Johann Lanz

KARREEBOSCH WIND ENERGY FACILITY (WEF): AGRICULTURAL COMPLIANCE STATEMENT IN TERMS OF THE PART 2 AMENDMENT, FINAL LAYOUT AND ENVIRONMNETAL MANAGEMENT PROGRAMME(EMPr) APPROVAL.

Figure 1. Map of the proposed final layout of the Karreebosch WEF and associated infrastructure

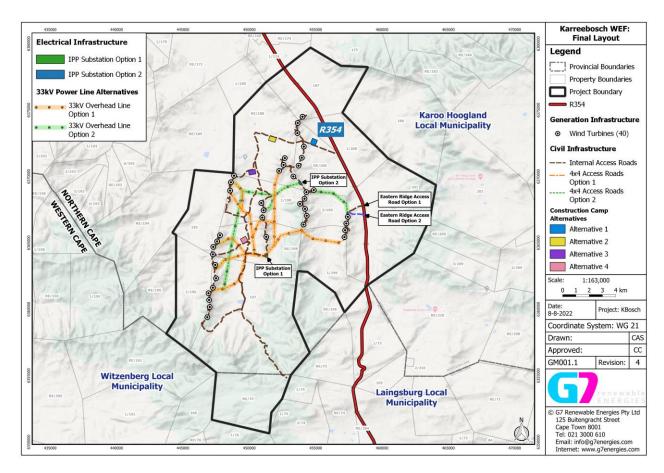
A map of the proposed final layout of the Karreebosch WEF and associated infrastructure, that was assessed here is given in Figure 1.

Figure 2. The proposed layout of the facility, including alternatives, overlaid on agricultural sensitivity, as given by the screening tool (green = low; yellow = medium; red = high; dark red = very high).

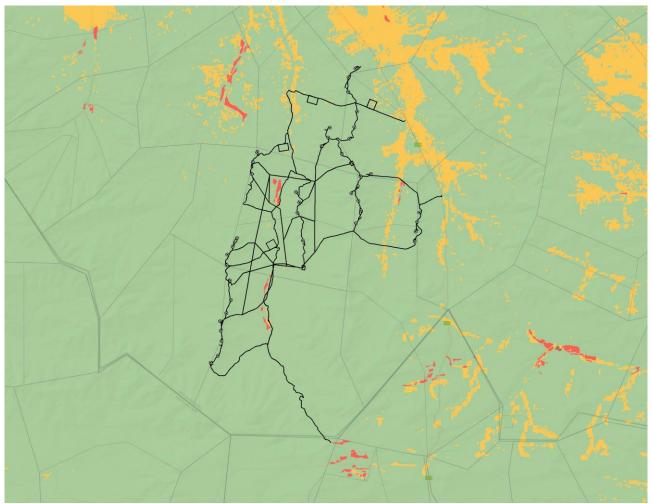
The layout is almost entirely on land of very low potential which is rated as low agricultural sensitivity. Only a small part is on medium sensitivity, which, for all practical purposes, has the same agricultural production potential as the low sensitivity land. The layout entirely avoids any land that is rated more than medium sensitivity, and that would therefore be a higher priority in terms of its conservation for agricultural land use. The final layout is therefore acceptable in terms of agricultural impact.

Due to the very low agricultural production potential of the site, and the effectively uniform agricultural conditions across the site, there will be absolutely no material difference between the agricultural impacts of any of the proposed alternatives. These include alternatives for construction camps, substations, 4X4 access roads and access roads off the R354. All alternatives are considered acceptable.
